## COUNCIL ASSESSMENT REPORT

<b>Panel Reference</b>	PPSSEC-164
<b>DA Number</b>	DA2021/0301
<b>LGA</b>	<b>Canada Bay Council</b>
<b>Proposed Development</b>	Demolition of an existing multi storey car park and construction of a 5-storey commercial office building comprising the Hewlett Packard Enterprise Headquarters, along with basement parking, Improvements to the existing hardstand car parking area, site landscaping, and public domain works to Blaxland Avenue.
<b>Street Address</b>	410 Concord Road, Rhodes - Hewlett Packard Site
<b>Applicant/Owner</b>	Saul Moran/ Hewlett Packard Australia Pty Ltd
<b>Date of DA lodgement</b>	8 November 2021
<b>Total number of Submissions</b> <b>Number of Unique Objections</b>	<ul style="list-style-type: none"> <li>• [6]</li> <li>• [6]</li> </ul>
<b>Recommendation</b>	<b>Refusal</b>
<b>Regional Development Criteria (Schedule 7 of the SEPP (State and Regional Development) 2011</b>	Clause 2, Schedule 7 of the SRD SEPP

<b>Report prepared by</b>	<b>Leonie Derwent</b>
<b>Report date</b>	13 July 2022

**Figure 5** Render showing proposed site levels in respect to the top level of the existing multi level carpark (See Photo at Figure 7)

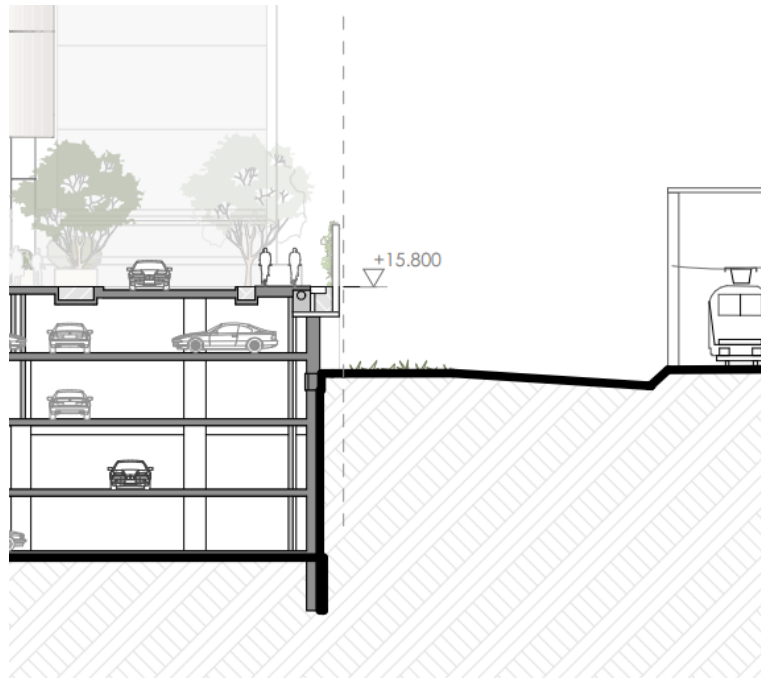
Further to the above, the majority of the width of the accessway along the western boundary which is designed to cater for vehicles, pedestrians and cyclists, is allocated to vehicles. While no dimensions are provided on the plans it appears that the shared cycleway and pedestrian pathway is only approximately 3 metres wide. It is shielded from the railway line by a wall. This issue has been raised by the Design Review Panel and surrounding land users concerning establishing altered finished levels and the consequences of these levels in the context of the Business Park lands. With respect to proposed ground levels, the key issues and recommendations of the DRP minutes state:

As shown below in extracts from the documentation which has been submitted as part of the application, the access for pedestrians and cyclists along the western side of the site is not necessarily enhanced by the proposal as the majority of the space is allocated to vehicles. The existing pathway is landscaped on both sides and is separated from vehicles.
